# Access Compliance Report

## Public Rights-of-Way

### (Curb Ramps)

Intersection ID: 49698	Main Street: LOUGHLIN_LN	Cross Street: MADISON_HILL_CT	Location: SE
ADA ID: 5C096B161F7D	Ramp Type: Perp	Initial Pass/Fail: Fail	Overall Compliance: No
Severity Score: 21.25			
Codes/Mitigation Info/Possible Solution		Field Measurements/Component Compliance

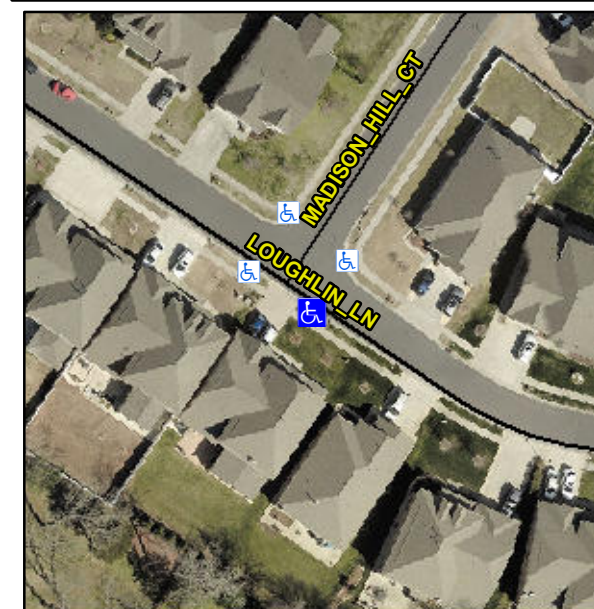
**Not Found, R304.5.1, R304.2.2**

Compliance	Description	Data	Compliance	Description	Data
N/A	Ramp Length (in)	47.0	No	Ramp Slope (%)	9.7
No	Ramp Width (in)	47.0	Yes	Ramp XSlope (%)	0.9
N/A	Flare Type LT	N/A	N/A	Flare Type RT	N/A
N/A	Flare Slope LT (%)	N/A	N/A	Flare Slope RT (%)	N/A
N/A	Flare Traversable LT?	N/A	N/A	Flare Traversable RT?	N/A
N/A	Landing Length (in)	N/A	N/A	DWS Provided?	N/A
N/A	Landing Width (in)	N/A	N/A	DWS Contrast?	N/A
N/A	Landing Slope (%)	N/A	N/A	DWS Length (in)	N/A
N/A	Landing X Slope (%)	N/A	N/A	DWS Full Width?	N/A
N/A	Landing Curb? (Y/N)	N/A	N/A	DWS Offset (in)	N/A
N/A	Shared Landing?	N/A			
N/A	Gutter Ponding?	N/A	N/A	Gutter Slope (%)	N/A
N/A	Gutter Lip Ht (in)	N/A	N/A	Gutter X Slope (%)	N/A
N/A	Painted X Walk1?	No	N/A	Painted X Walk2?	N/A
	X Walk 1 Direction	To NE		X Walk 2 Direction	N/A
N/A	X Walk 1 Width (in)	N/A	N/A	X Walk 2 Width (in)	N/A
	X Walk 1 Slope (%)	1.1		X Walk 2 Slope (%)	N/A
	X Walk 1 X Slope (%)	2.5		X Walk 2 X Slope (%)	N/A

N/A	Ramp inside XWalk1?	N/A	N/A	Ramp inside XWalk2?	N/A
	Road Slope (%)	N/A	N/A	Clear Space?	N/A
	Road X Slope (%)	N/A	N/A	Clear Space to XWalk (in)	N/A
N/A	Any Obstructions?	N/A	N/A	Storm Grate/Utility Hazard?	N/A
	Obstruction Type			Storm Grate/Utility Type	
		N/A			N/A
			Yes	Surface Condition? (G/P)	Good

**Remove & Replace Entire Ramp.**
